## DEPARTMENT OF COMMERCE

#### Endangered and Threatened Wildlife; Sea Turtle Conservation Requirements

**ACTION:** Final rule.

**SUMMARY:** NMFS is amending the turtle excluder device (TED) regulations to enhance their effectiveness in reducing sea turtle mortality resulting from trawling in the southeastern United States. NMFS has determined that: some current approved TED designs do not adequately exclude leatherback turtles and large, immature and sexually mature loggerhead and green turtles; several approved TED designs are structurally weak and do not function properly under normal fishing conditions; and modifications to the trynet and bait shrimp exemptions to the TED requirements are necessary to decrease lethal take of sea turtles. These amendments are necessary to protect endangered and threatened sea turtles in the Atlantic Area (all waters of the Atlantic Ocean south of the North Carolina/Virginia border and adjacent seas, other than the Gulf Area, and all waters shoreward thereof) and Gulf Area (all waters of the Gulf of Mexico west of 81° W. long. and all waters shoreward thereof).

Figure 12 to Part 223

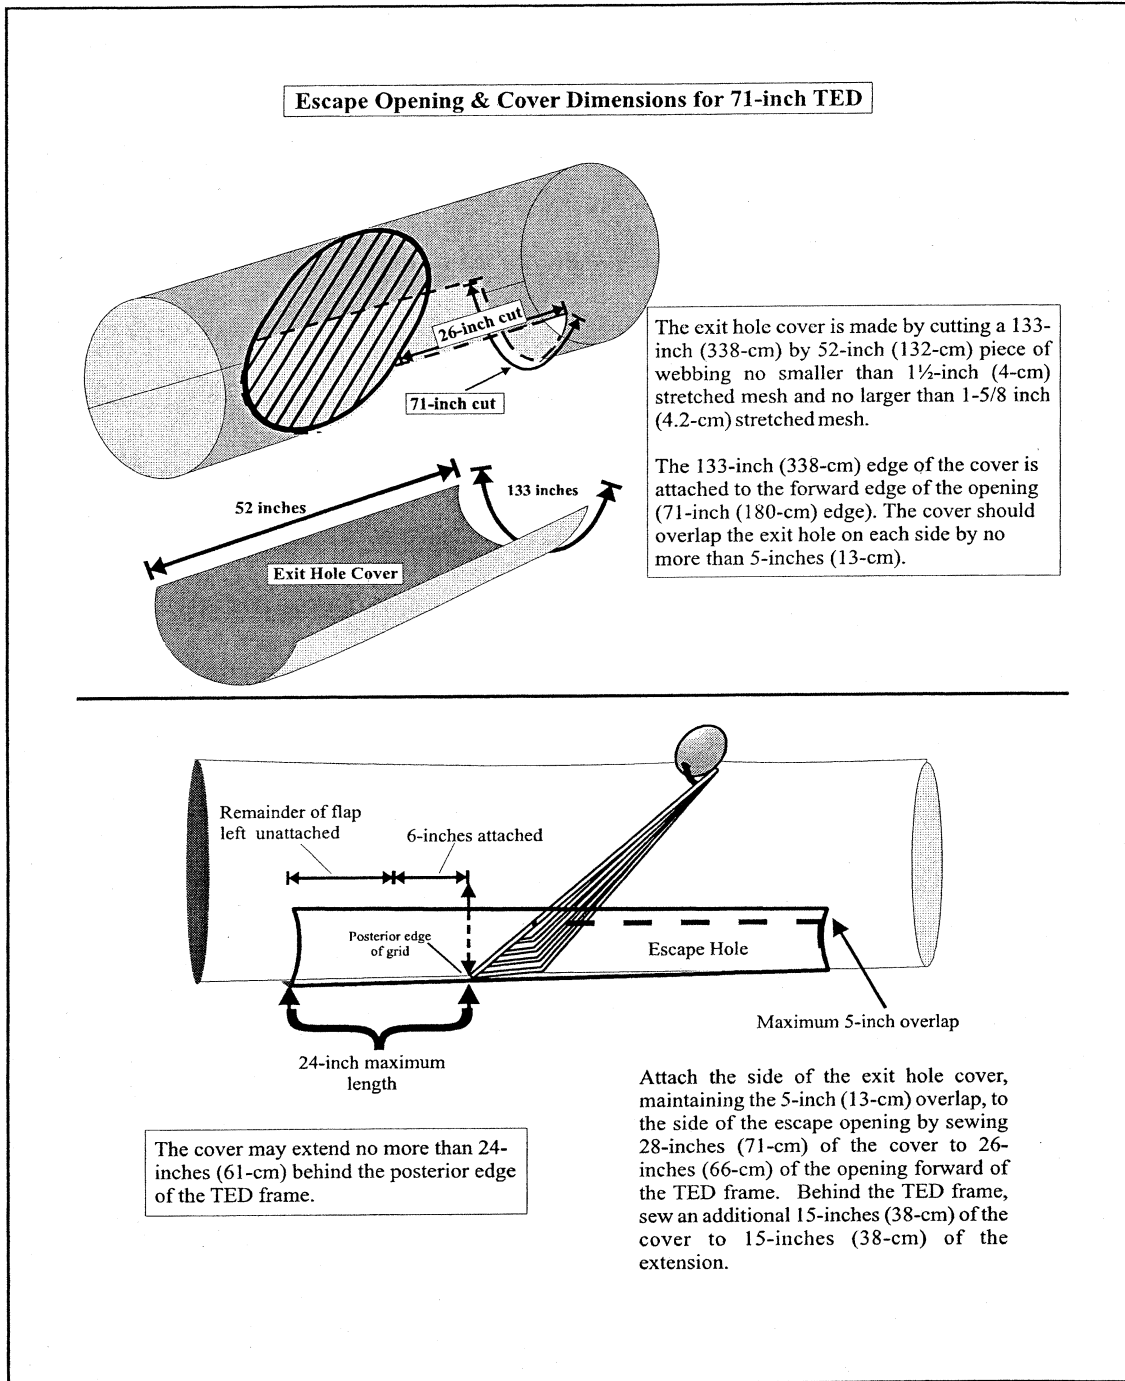
(ii) *71-inch offshore TED Flap*. The flap must be a 133-inch (338-cm) by 52-inch (132-cm) piece of webbing. The 133-inch (338-cm) edge of the flap is attached to the forward edge of the opening (71-inch (180-cm) edge). The flap may extend no more than 24 inches (61 cm) behind the posterior edge of the grid (Figure 12 to this part illustrates this flap).

Figure 15 to Part 223

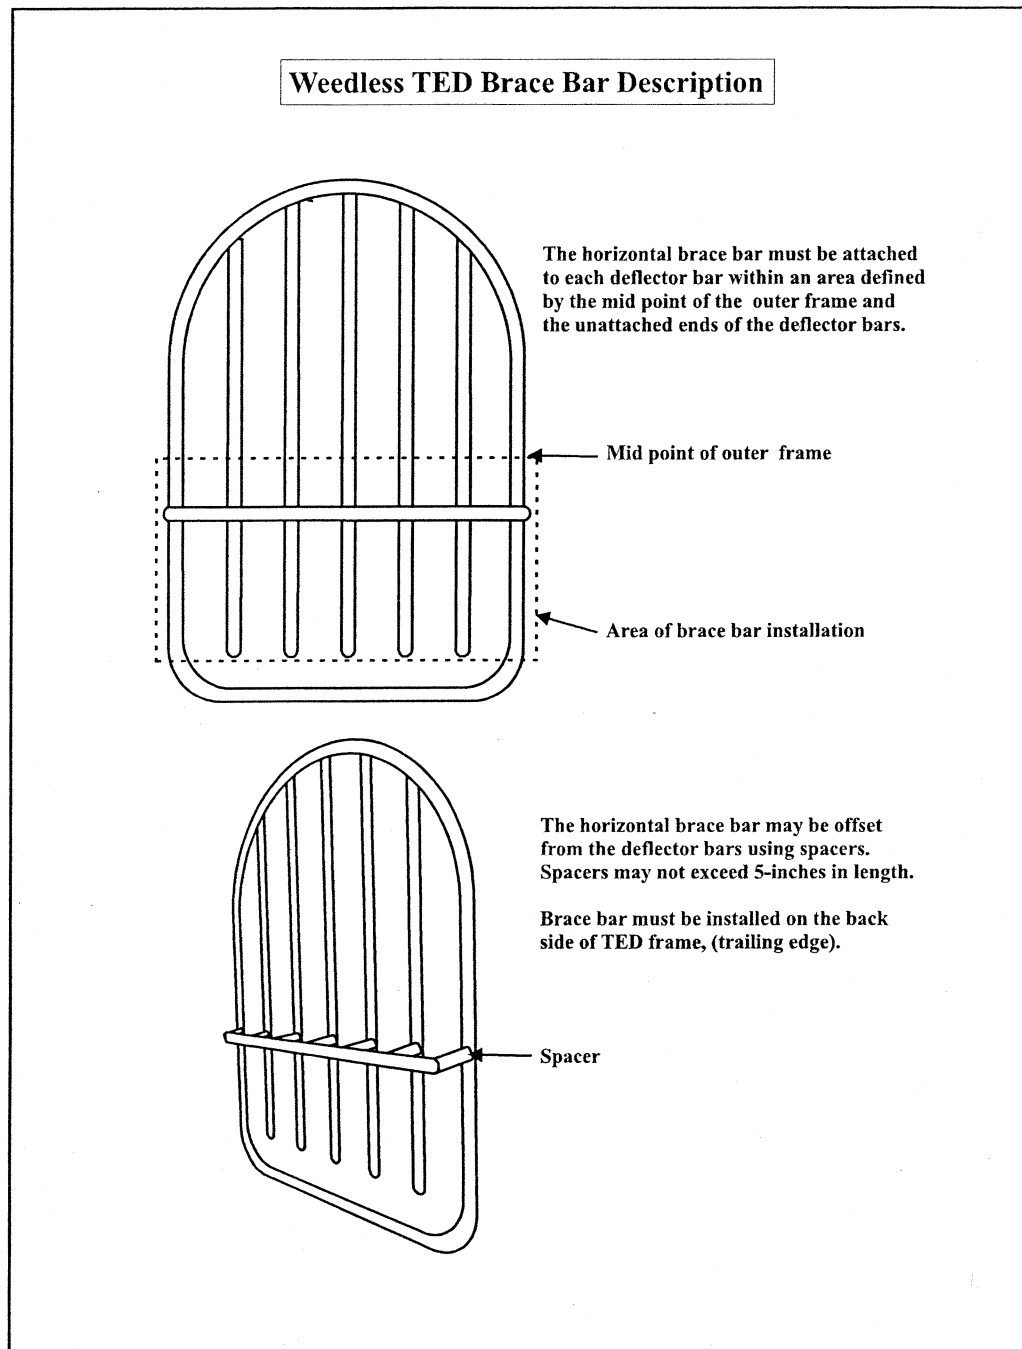
horizontal brace bar may be offset behind the deflector bars, using spacer bars, not to exceed 5 inches (12.7 cm) in length and constructed of the same size or larger pipe as the deflector bars. See Figure 15.
